FirstEnergy Nuclear Operating Company

March 7, 2008  
L-08-081

Beaver Valley Power Station, Unit Nos. 1 and 2  
BV-1 Docket No. 50-334, License No. DPR-66  
BV-2 Docket No. 50-412, License No. NPF-73  
License Renewal Application Amendment 2: Reply to Request for Additional Information  
Regarding Severe Accident Mitigation Alternatives for Beaver Valley Power Station  
Units 1 and 2 License Renewal

Reply to Request for Additional Information Regarding the Analysis of Severe Accident Mitigation Alternatives (SAMAs) for Beaver Valley Units 1 and 2 License Renewal

Figure 2.B-1a: Noble Gas and Cesium Iodine release fractions for BVPS Unit 2 Release Class BV1

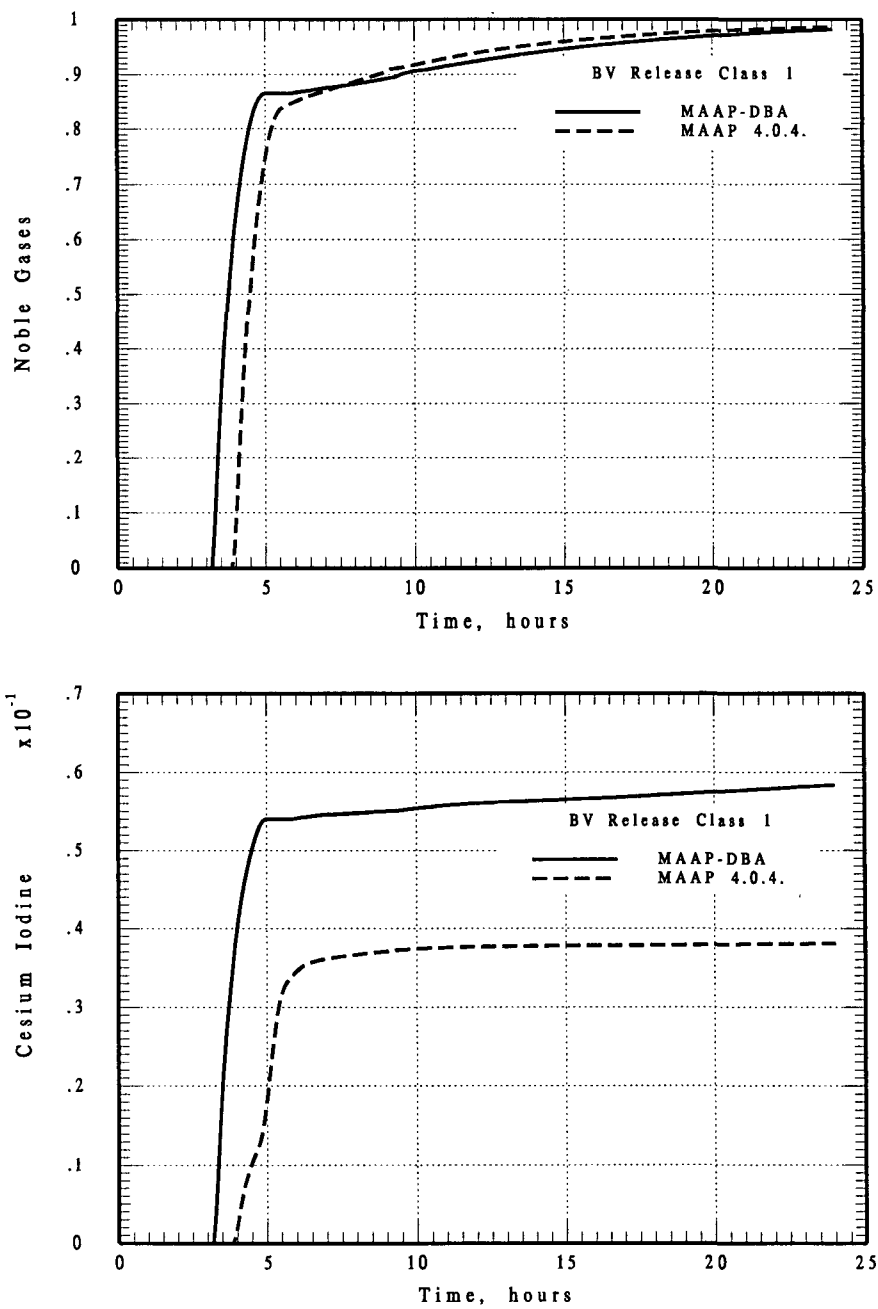
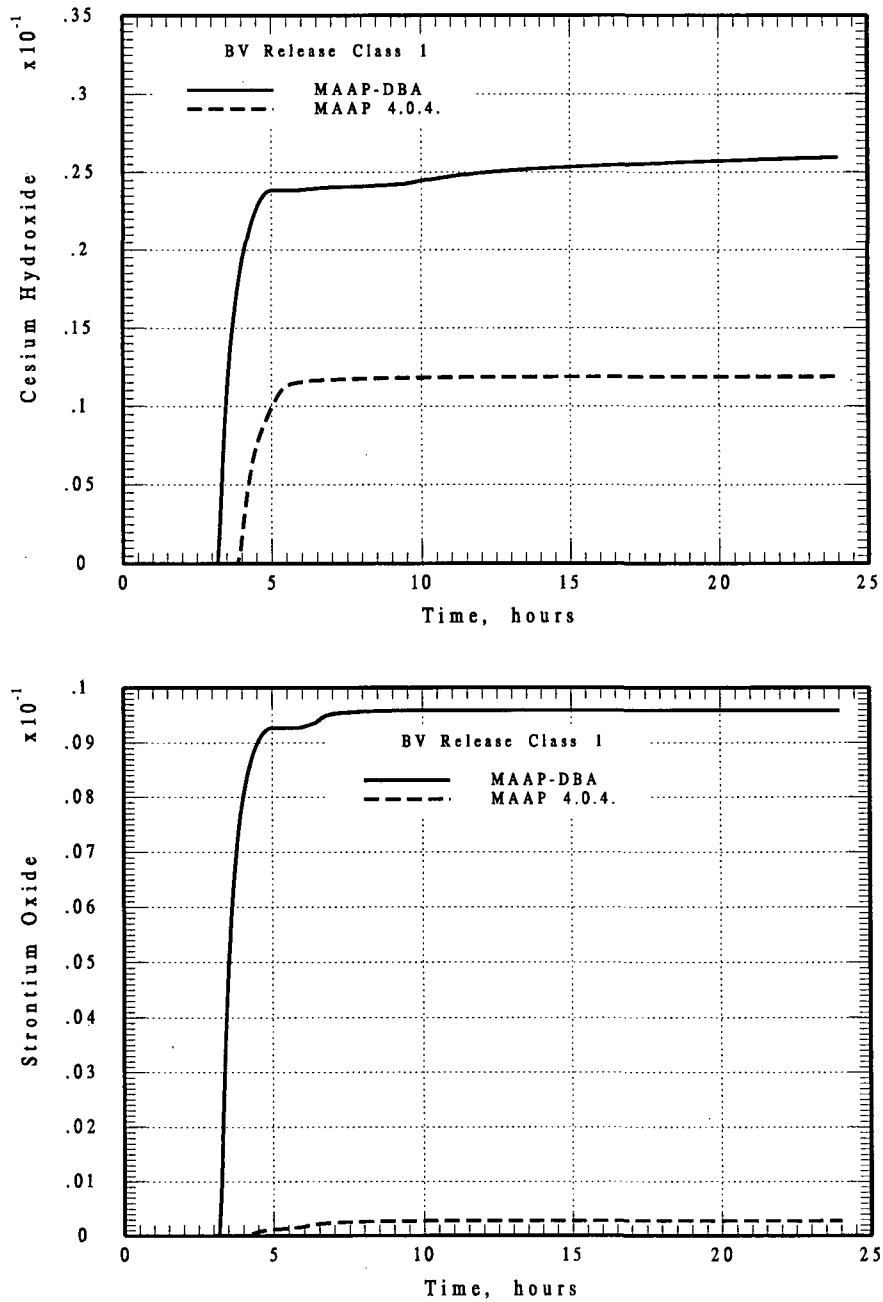
- b. It is noted that MAAP-DBA was used to support the Level 2 analysis rather than the more widely-used MAAP 4.0.4 computer code. Discuss the rationale for using MAAP-DBA and the estimated impact of this code choice on accident progression and source terms. Provide a comparison of the source terms obtained using MAAP-DBA with source terms based on MAAP 4.0.4 for comparable sequences.**

The results of these comparisons in terms of fission product release fractions are illustrated in Figures 2.B-1a through 2.B-4b, shown below, for the major fission product groups (i.e., noble gas constituents, cesium iodine (CsI), cesium hydroxide (CsOH), and a representative non-volatile fission product - strontium oxide (SrO)). As shown in these figures, the comparison between the two computer code results for the four cases either demonstrate good agreement or illustrate that the results generated using the MAAP-DBA computer code are bounding. For the most part, the release fractions followed the same trend and the release fractions were on the same order of magnitude and typically differ by no more than a factor of 2 to 3. It is important to note that these differences occur when the release fractions are relatively small such that the differences can be due to small differences in the models.
